TECHNICAL BULLETIN

MODEL/DERIVATIVE:
Discovery Series II (LT)

Bulletin N°: 0015
CDS. ref: L8895bu
Issue: 2
Date: 27.01.04

RADIATOR TOP COOLANT HOSE - LEAKING
ACE high-pressure hose chafing radiator top coolant hose.

1

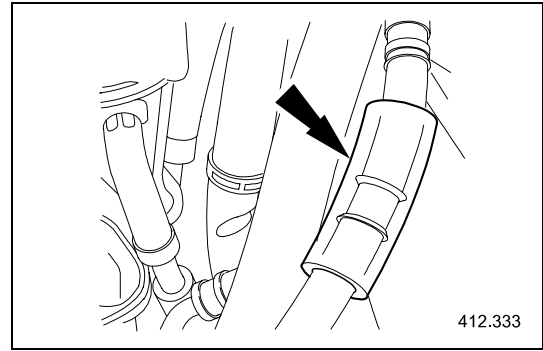
5. If installed, remove the foam protector from the ACE high pressure hose, and discard (see illustration 1).
